FIRE & SAFETY AUDIT REPORT OF ALL THE BUILDINGS AT NABA DIGANTA

Volume III

Naba Diganta Industrial Township Authority

G. Stair Case & Lift Shaft.

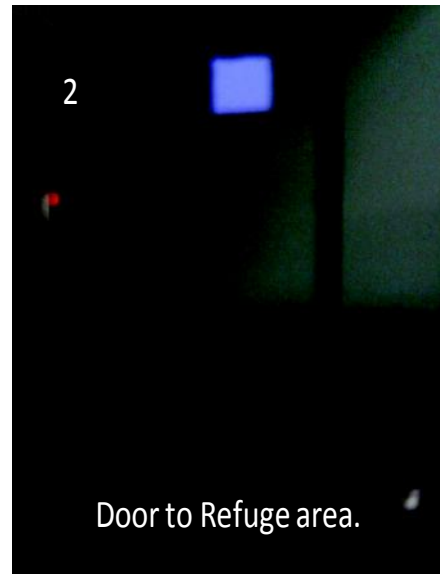
1. Fire retardent door be fixed in the Refuge area.
2. DG exhaust lines goes through Service staircase hence the available width at the landings is limited to 970 mm.
3. Material stored in Staircase eg flower pots dustbins etc.

H. Assembly Area.

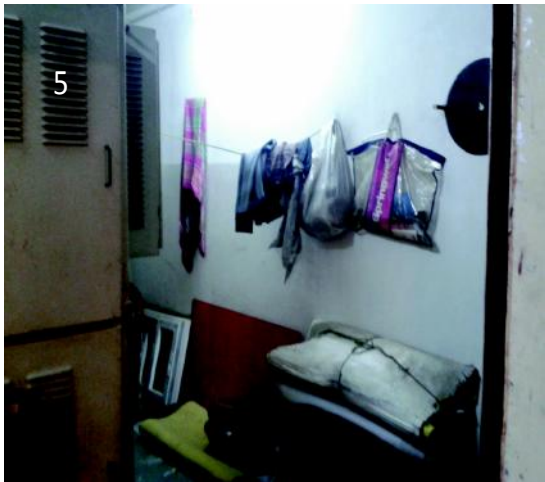
1. Assembly area is not mention in building premises. Assembly area should be indicated& maintained as per NBC part-VI
